**CITY OF MT. MORRIS  
PLANNING COMMISSION AGENDA  
March 17<sup>th</sup>, 2025  
6:30 p.m.**

**RE: Valley Liquor, Gas Station, and Food Truck Court Site Plan Review**

ROWE Professional Services Company is in receipt of a site plan for review for Valley Liquor, Gas Station, and Food Truck Court at 1079 E. Caro Road. We have reviewed the plans for compliance with the city's zoning ordinance and offer the following comments.

**SKETCH OF CROSS-ACCESS EASEMENT**  
 PART OF "WALKER'S ADDITION TO MT MORRIS" AND  
 "MAP OF ADDERLEY'S ADDITION TO THE VILLAGE OF MOUNT MORRIS"  
 CITY OF MT MORRIS, GENESEE COUNTY, MICHIGAN

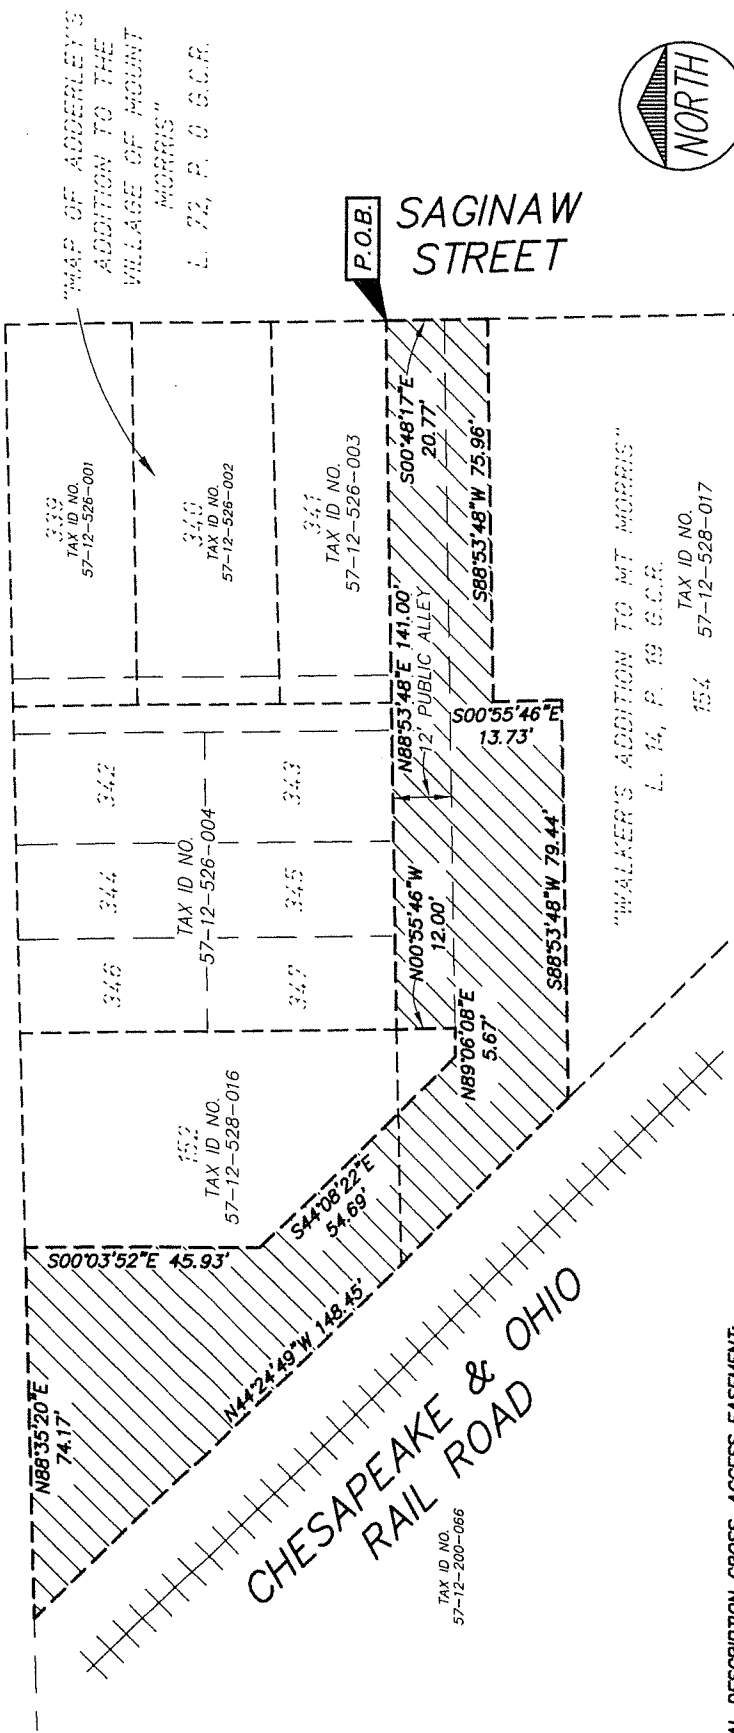
- Do cross access/maintenance easements exist for these parcels and the DDA owned parking lot?
- The site plan includes a food truck area. It is our understanding that the city is reviewing which zoning district(s) food truck should be permitted in. Currently, they are not listed within the zoning ordinance.

- A cross-access agreement still has not been received from the Downtown Development Authority for parcel 57-12-528-018 or from the owner of parcel 57-12-528-016. Section C indicates that access to adjacent parcels is not needed to have adequate circulation, according to the submitted site plans on sheet S1 on parcel 57-12-528-016 is labeled that cross-access easement is required. On sheet S3 the exit of fuel delivery tankers indicates crossing parcel 57-12-528-018.
